Please find attached our draft Drawing Nos. M380/128 Revision E and M380/129 Revision D, for review – this addresses the ecology comments as follows;

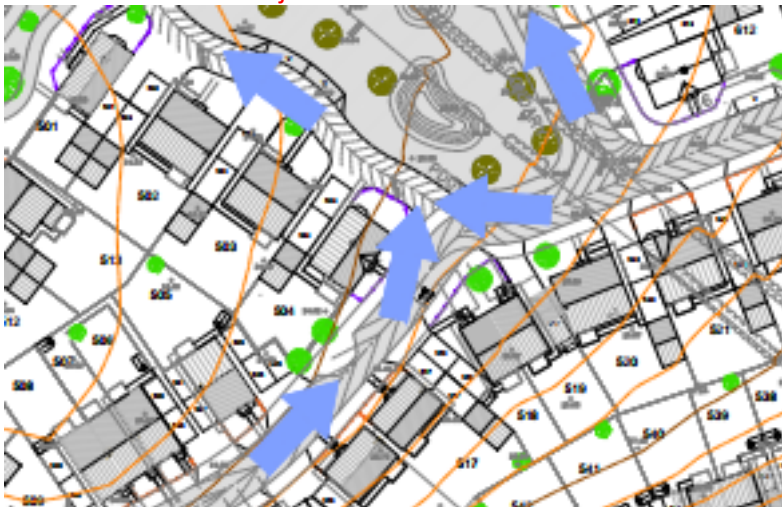
- *I have reviewed the updated condition 11 Drainage Maintenance Management Plan (November 2023), and the Phase 3 Drainage Statement (Issue 3 November 2023). On the Exceedance flow routes (Rev D, sheet 1 of 2) there is a place where 2 flow arrows appear to converge (circled in red), which does not make sense to me;*

This was meant to show that exceedance flows will converge at the driveway junction and flow down the driveway (north) – but I can see it could be seen otherwise. The arrow locations have been adjusted to make the flow route more obvious;
